ADDRESS . : 182 ADRIAN ST
CONTRACTOR : SCOTT LEE HOMES INC
OWNER . . : SCOTT LEE HOMES INC #22
PARCEL . . : 05-0635- - -0103- -38-
APPL NUMBER: 06-50016126 CP NEW RESIDENTIAL (SFD)
DIRECTIONS : JOHNATHAN RIDGE #22
210 TOWARDS ANGIER LEFT ONTO HWY 55 TO
42 THRU FUQUAY LEFT ONTO TRUELOVE S/D
ON RIGHT 11/07/2006 01:48 PM JDAVIS

Re.: Foundation Excavation Observation
Lot 22 Jonathan Ridge Subdivision ; (Permit #:06-50016126)
Harnett County, NC
Project No.:07DLM-0326A

Subject: House Plan - Chapman
Roof Framing Revision
LDC Engineering Job No. 02-0210B

Figure 1

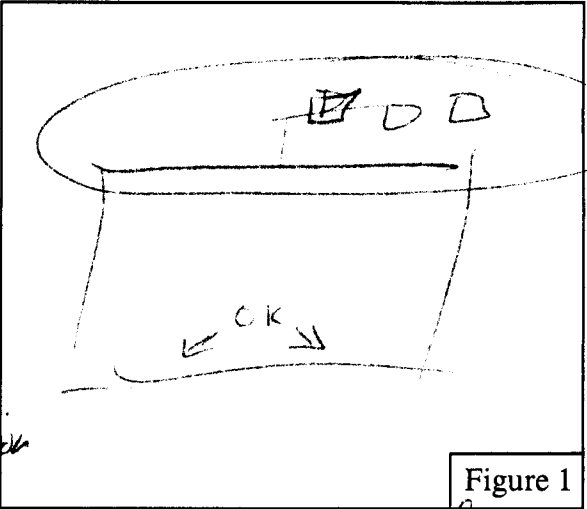
David Miller PE was onsite to
observe and test the bearing
conditions for the above
proposed project. The excavation
encountered yielding soils along the
area of the rear wall, and Perch water was observed.

A tailditch and sump pit may be excavated to allow removal of
water if needed (if water interferes with concrete placement.
Recommend overexcavation in the areas with wet yielding soil
approx 1-2 Ft (as needed in stump holes to reach firm soil) and backfill
the overexcavated areas with clean washed Stone
Will Return after work is completed to verify repair

ROOF FRAMING PLAN

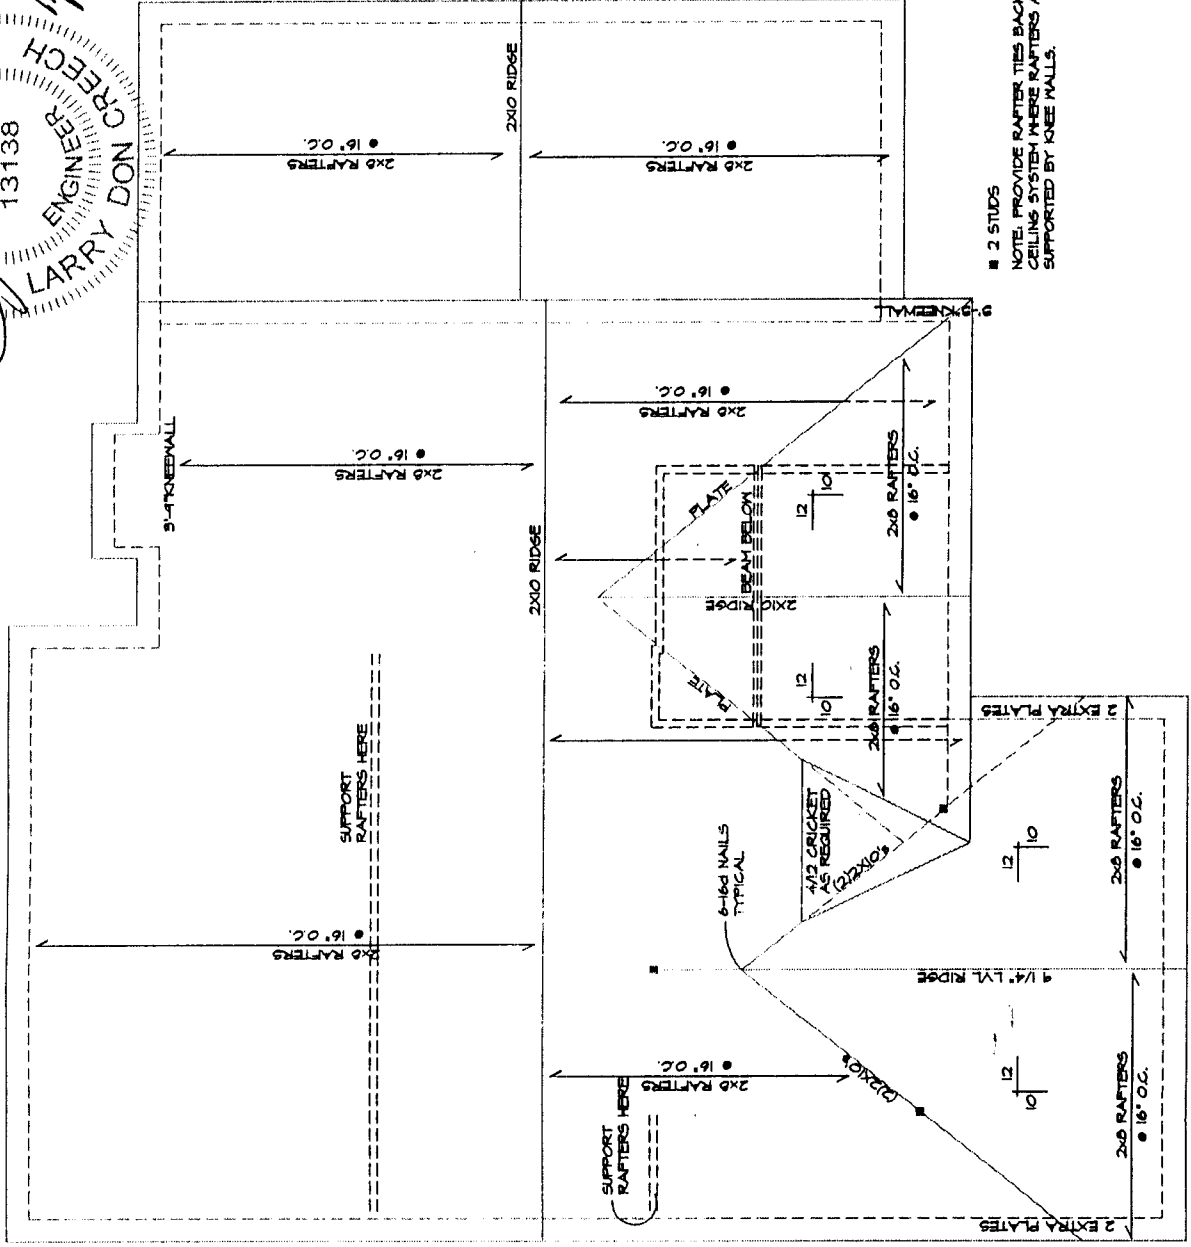
The roof may be framed according to the attached plan.

Also, the piers are to be dropped as noted on the foundation plan 9 1/4" instead of the 7 1/4" specified.

The foundation wall at the deck should be 8" thick instead of the pier and curtain wall specified.
